Appendix 6. Photo Survey, Safety and Compliance Audit - M2 shoulder existing route

This is Appendix 6 of the Bike North Audit of the M2 Interim Bicycle Detour as proposed by Transurban. It covers the existing sealed shoulder/cycle lane on the motorway and is included to give a comparison with other routes. This document should be read in conjunction with the other documents.

Principal Auditor : Doug Stewart (Bike North). Audit Dates: 14 January 2007, 16 January 2007, 30 January 2007,

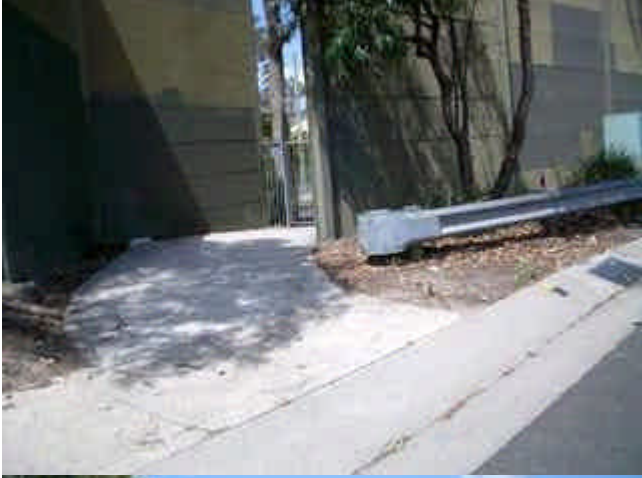
Location	Comments	Work
	1. Epping Road and Delhi Road corner. Cycle crossing of Epping Road. (facing north)	New cycle light crossing. Delay can be long due to priority given to Epping Road.	None
	2. Epping Road and Delhi Road corner. Cycle crossing of Delhi Road. (facing west)	Need cycle light crossing and kerb ramp widened on the west side. Crossing over slip lane should be included in a single phase.	Add cycle light and widen kerb ramp.
	3. Delhi Road at Epping Road corner. (facing north)	Cycle lane has been removed from the left of this road. This should not have happened. We presume that the RTA anticipated removal of westbound cycle lane some years ago, but did not advise cyclists.	Widen kerb lane (or resume some nature strip) and reinstate cycle lane leading to the M2.

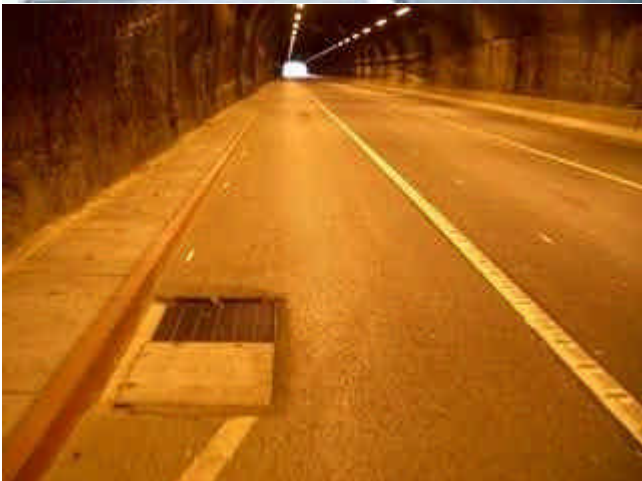
Location	Comments	Work
	<p>4. Delhi Road slip lane onto the M2 motorway. (facing north)</p>	<p>M2 cycle lane begins.</p>	<p>None</p>
	<p>5. M2 Motorway cycle lane, (facing west)</p>	<p>Cycle lane should be wider and left turn to works depot should be narrower.</p>	<p>Widen cycle lane.</p>
	<p>6. M2 Motorway cycle lane, (facing west)</p>	<p>2.5m wide cycle lane.</p>	<p>None.</p>
	<p>7. M2 Motorway cycle lane at on Herring Road on ramp, (facing west)</p>	<p>Cycle lane with standard crossing point.</p>	<p>None</p>
